PARTS & SERVICE NEWS

REF NO.	AT03244
DATE	Dec. 26, 2003
(C) Page 1 of 10

SUBJECT: WA700-3/WA800-3/WA900-3/WA1200-3
REPAIR OF BACKLASH AT ARM REST AREA

PURPOSE: To introduce modification procedure to repair the backlash of the AJSS arm rest section on WA700-3, WA800-3, WA900-3 and WA1200-3 wheel loaders

Fig. 1

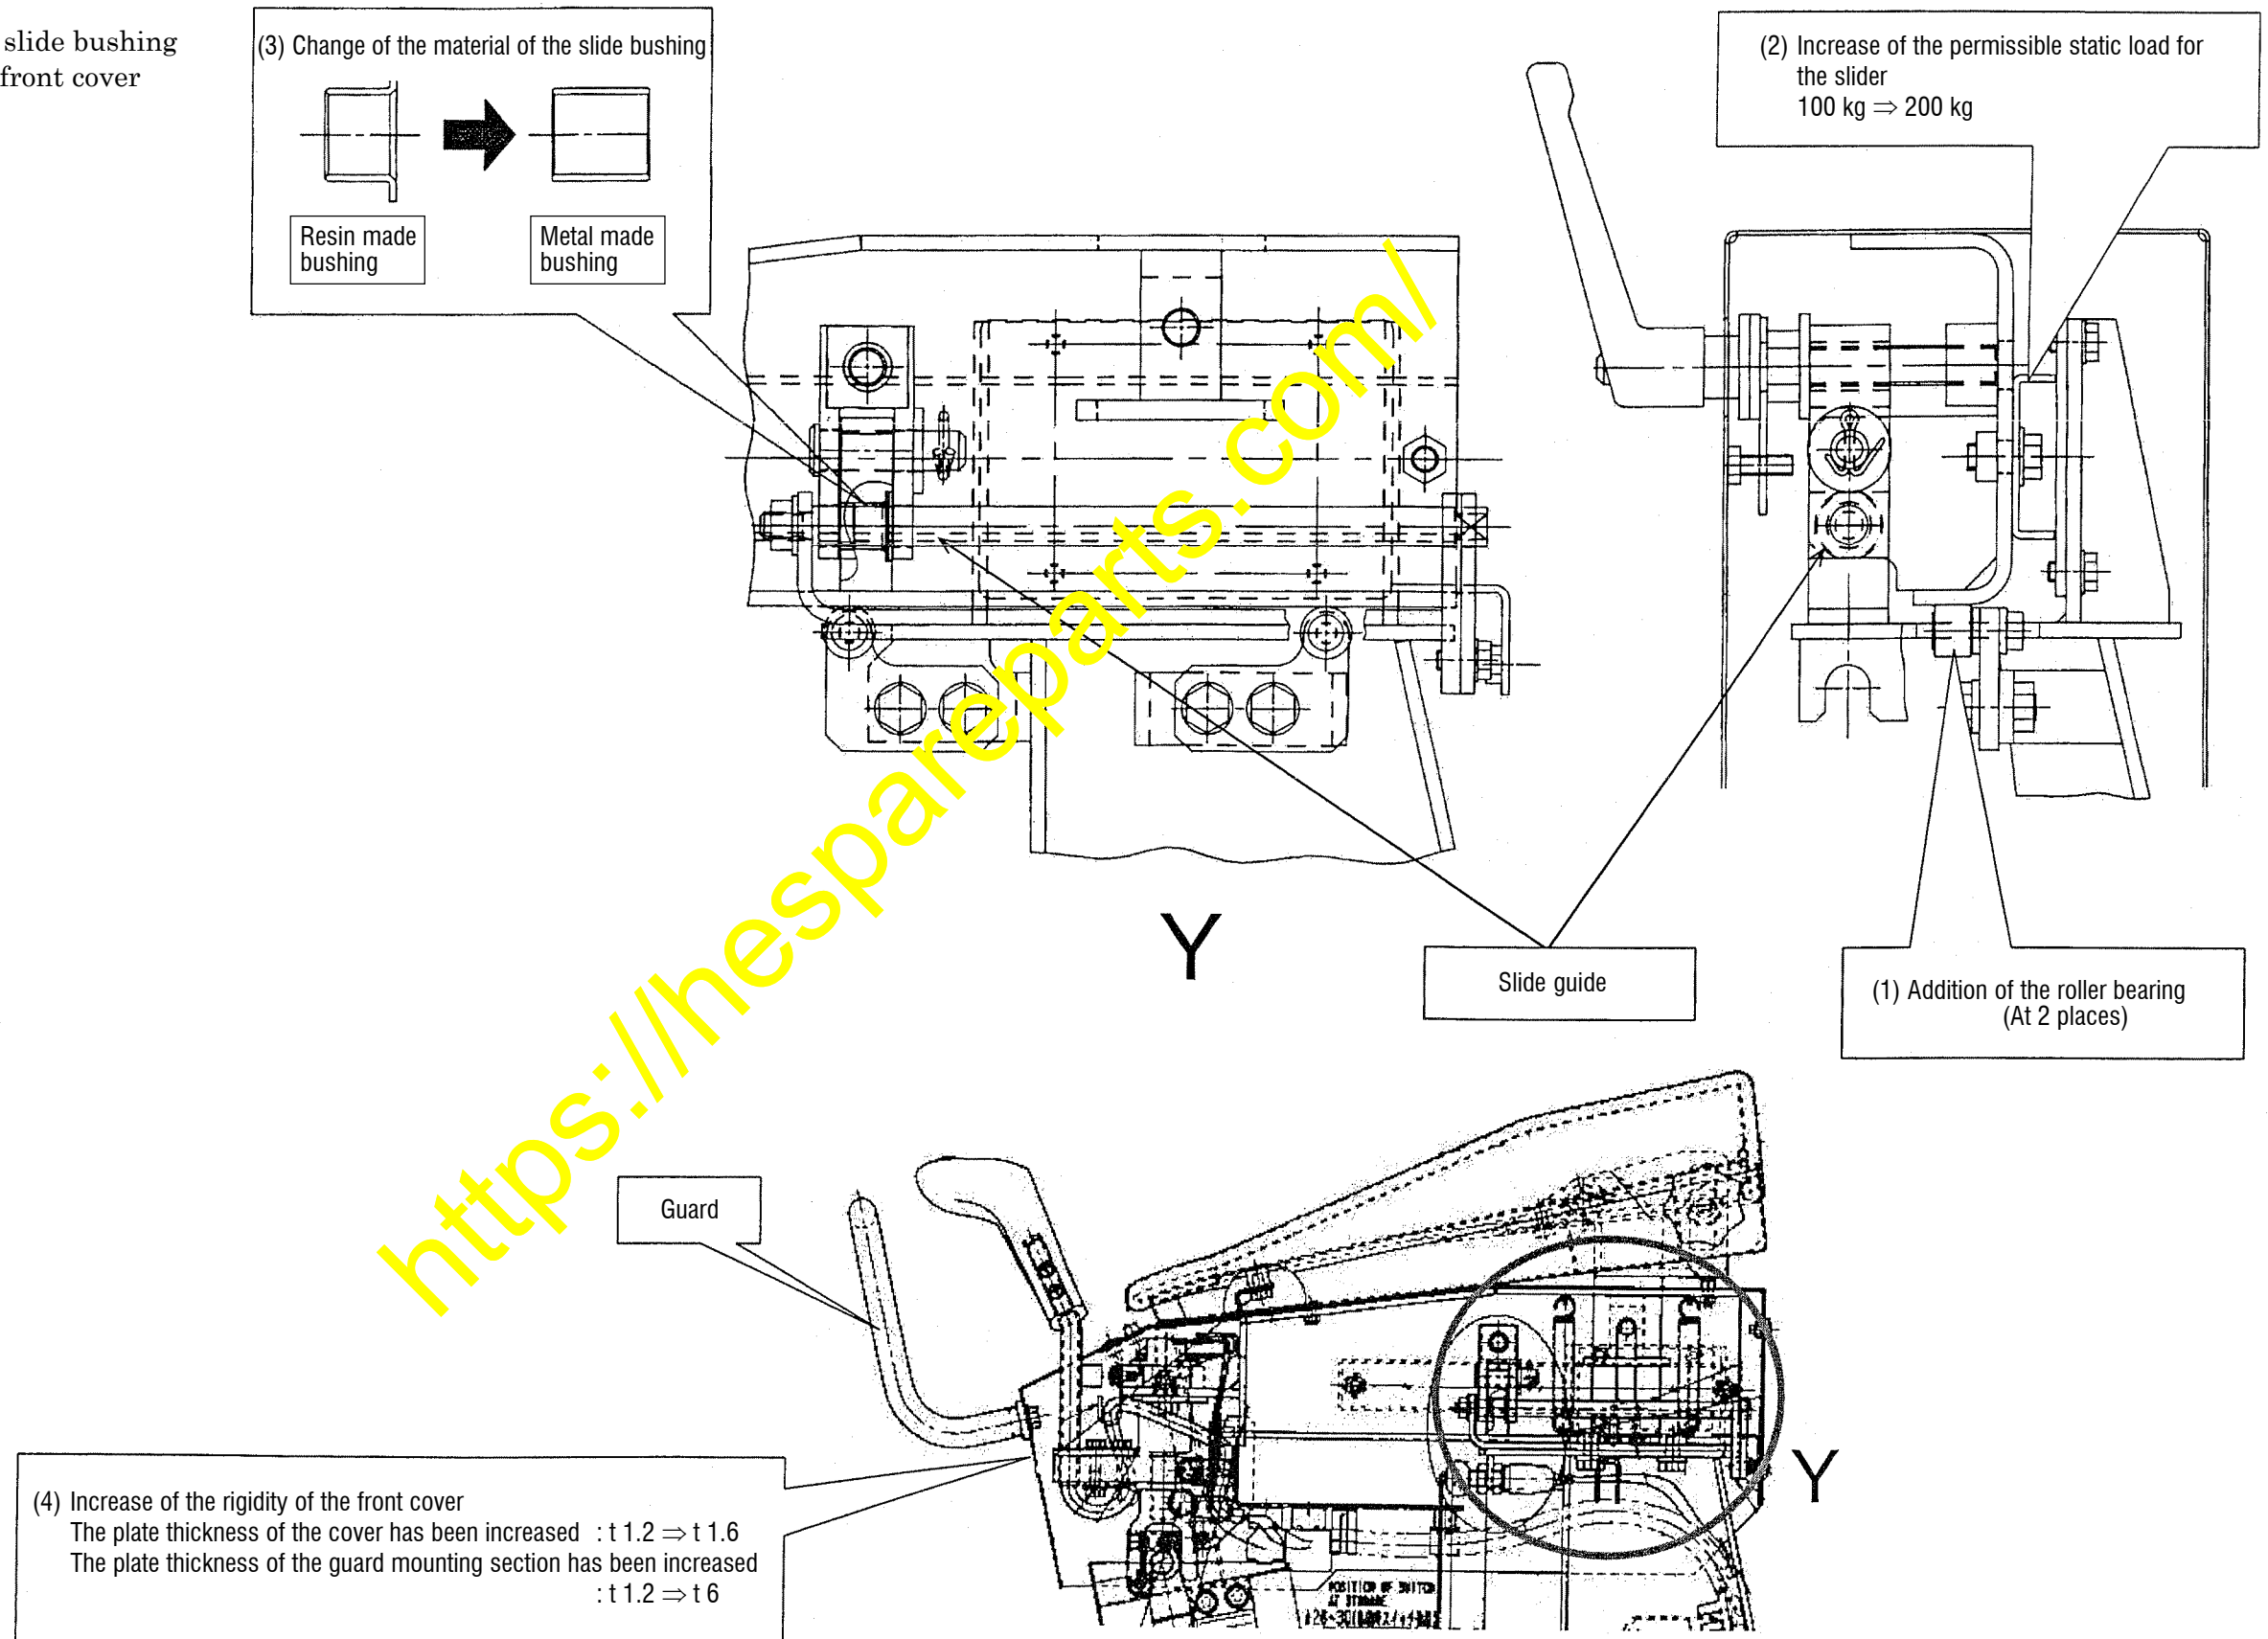
- (1) Addition of the roller bearing
- (2) Increase of the permissible static load for the slider
- (3) Change of the material of the slide bushing
- (4) Increase of the rigidity of the front cover

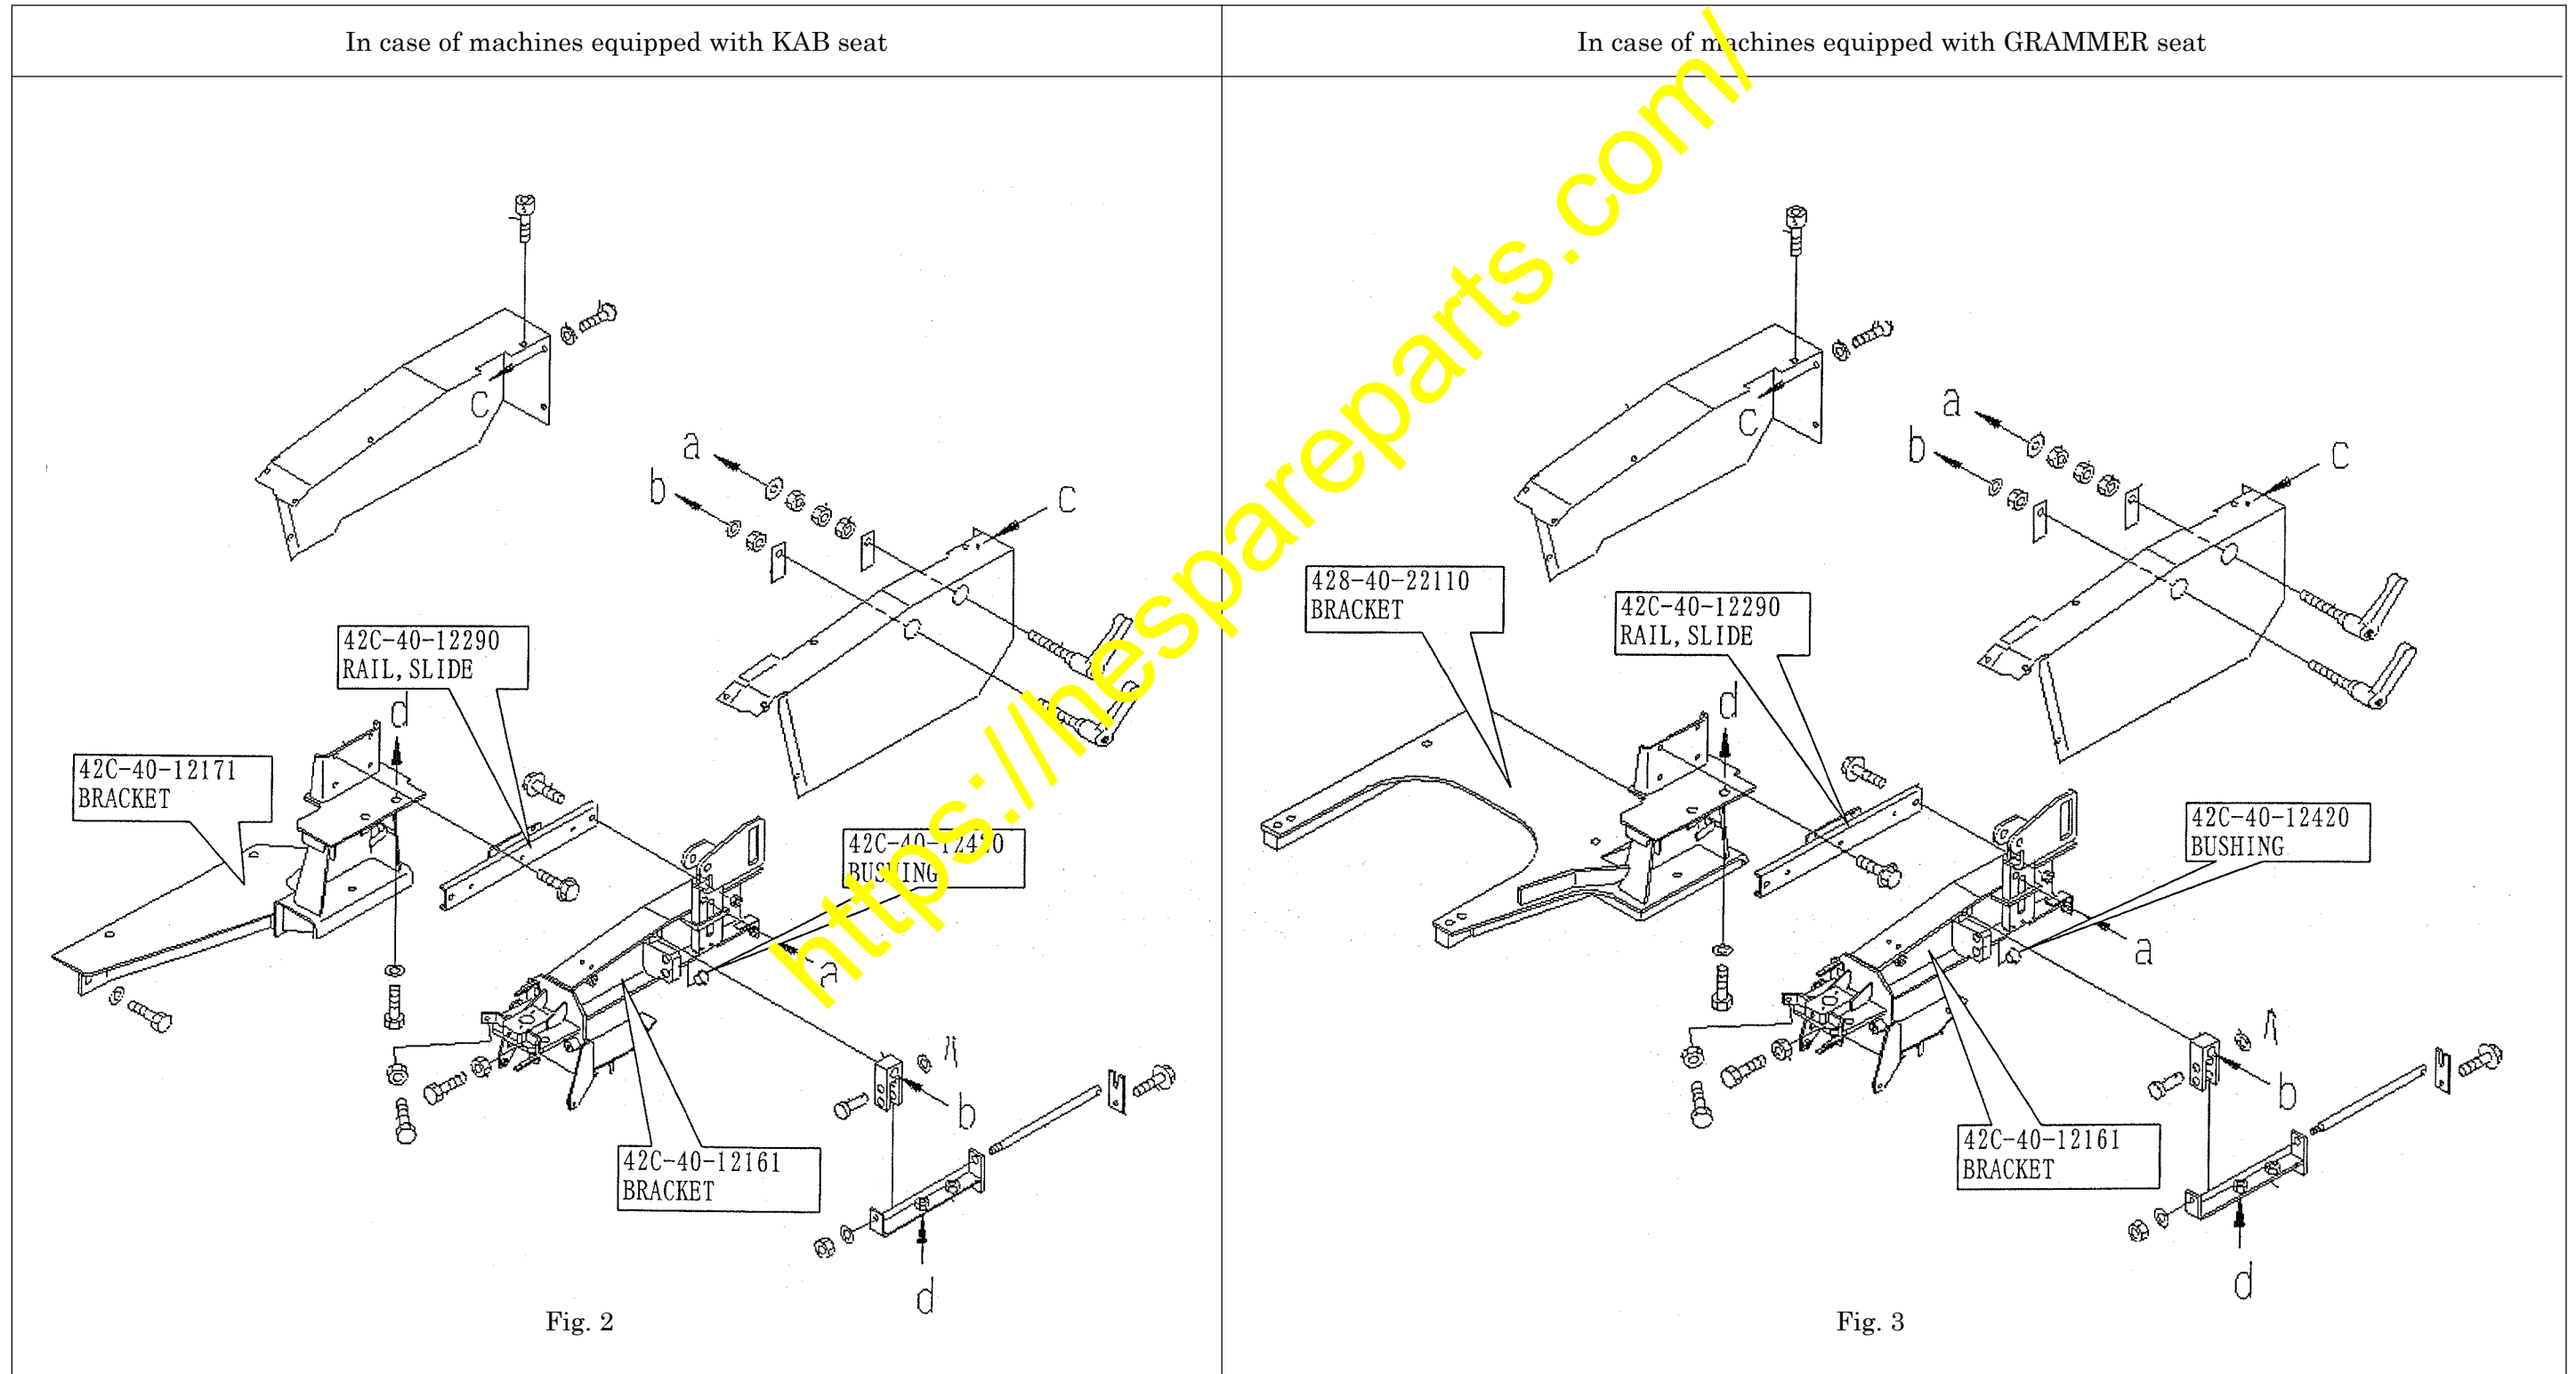
- (1) To make reworking, remove the parts with their part numbers shown in Fig. 2 or Fig. 3.
- (2) Since removed bolts and washers are being reused when carrying out the reinstallation work, store them carefully.
 - Regarding the part numbers of the bolts and washers, refer to the Parts Catalog.

Fig. 4

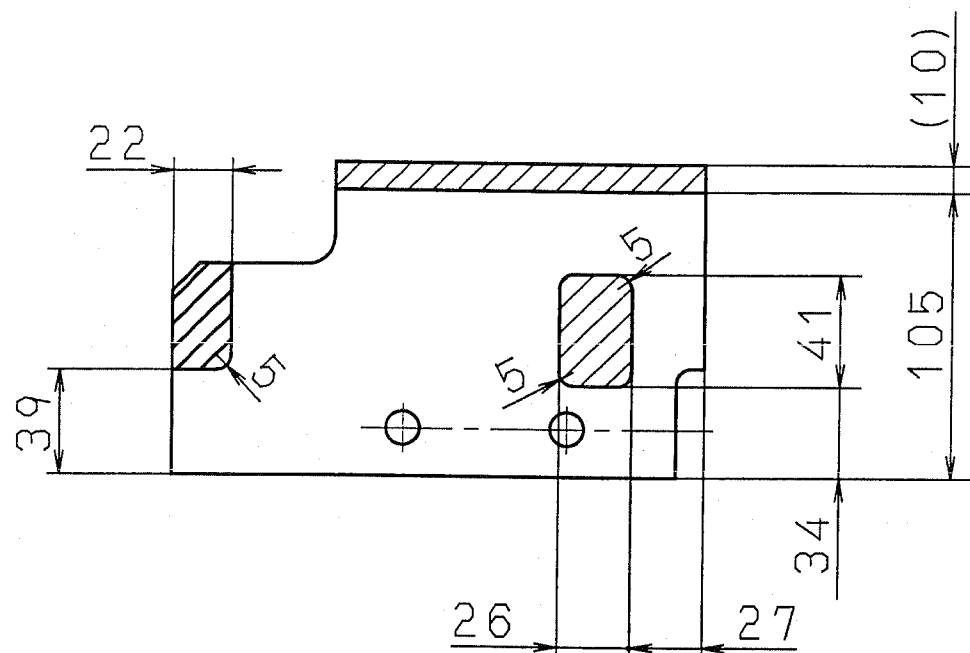
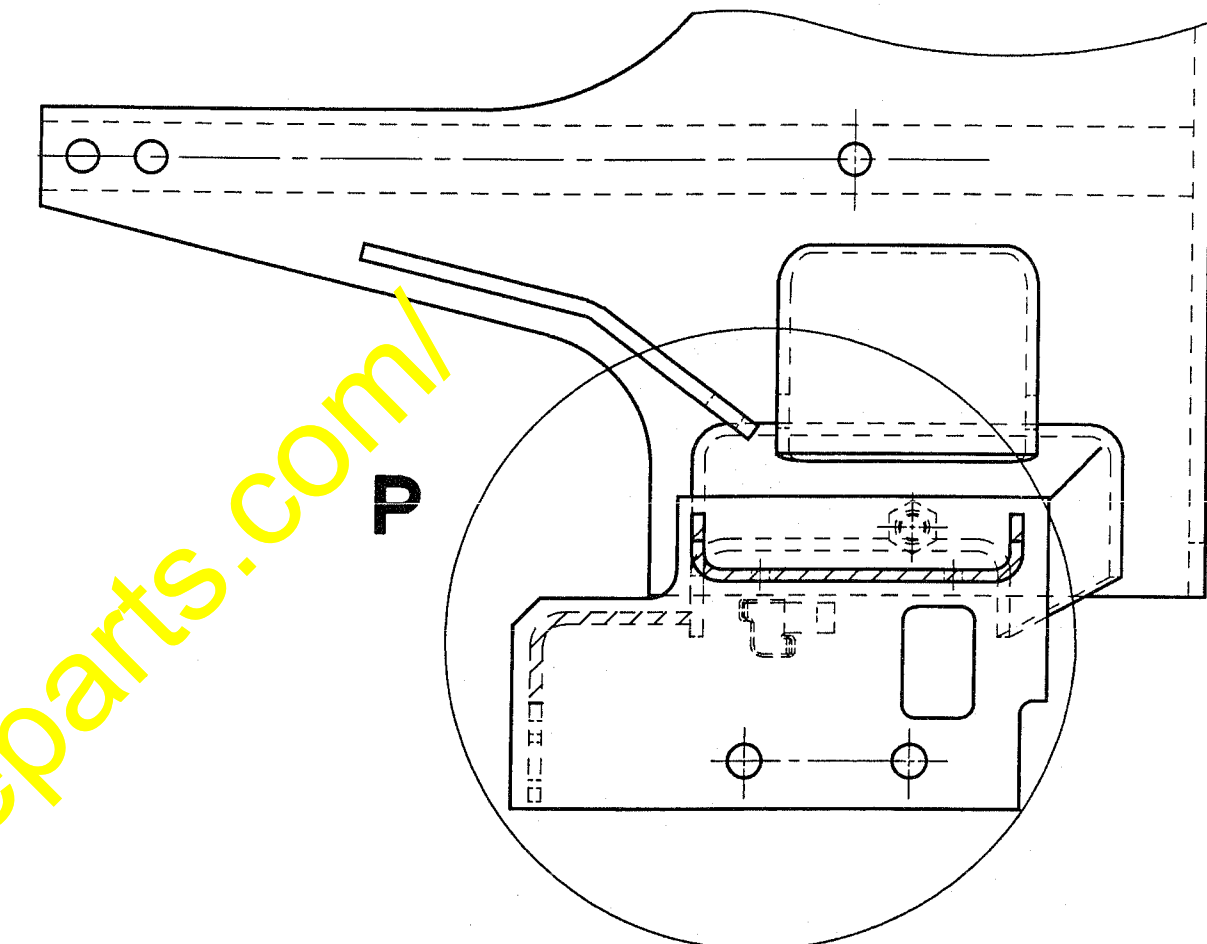
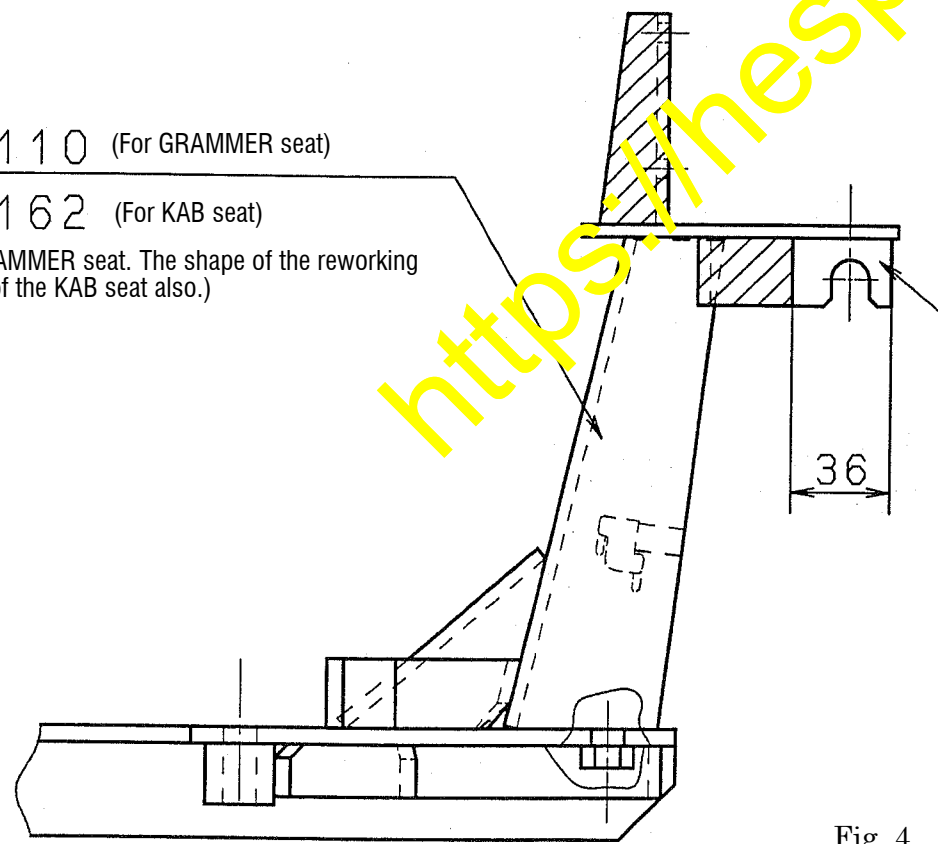
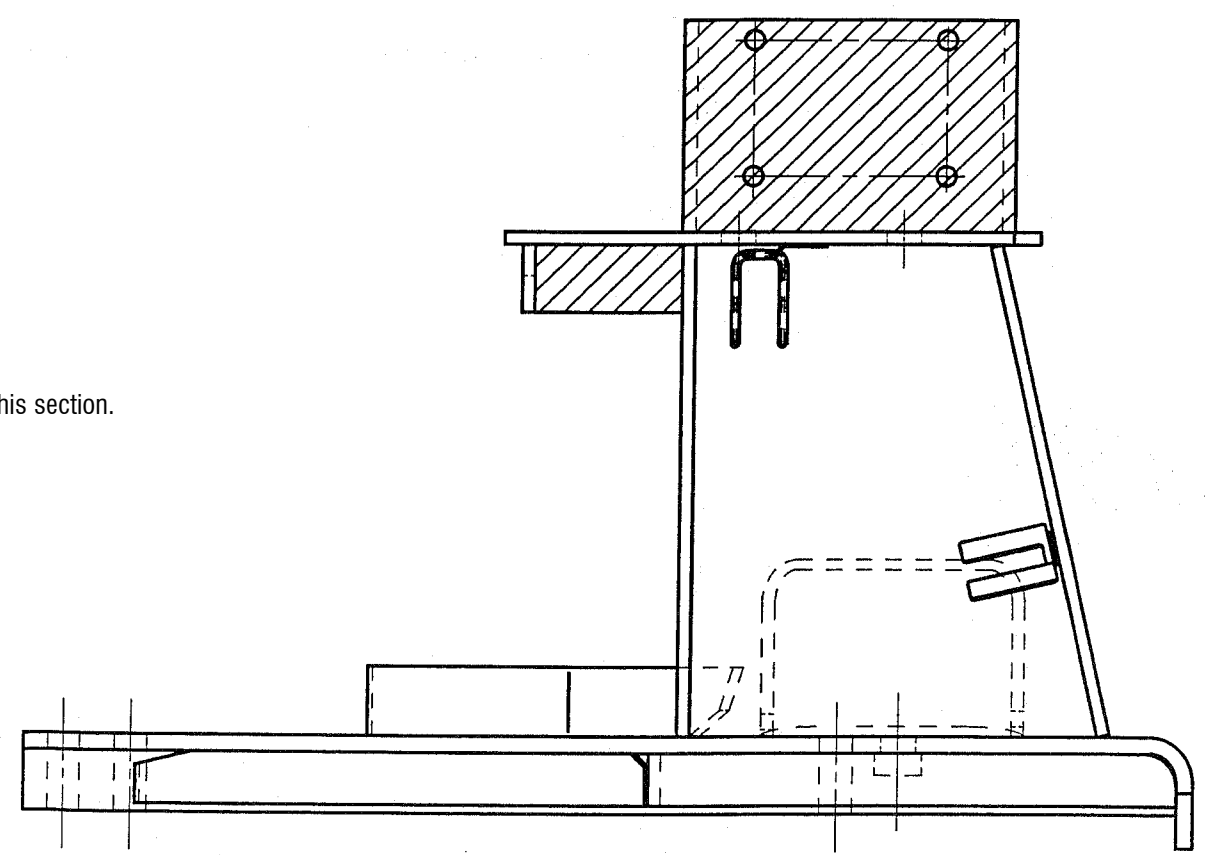
Cut off the hatched sections shown in Fig. 4 from the AJSS base bracket.

(This drawing is shown the GRAMMER seat. The shape of the reworking sections are the same in case of the KAB seat also.)

Leave this section.
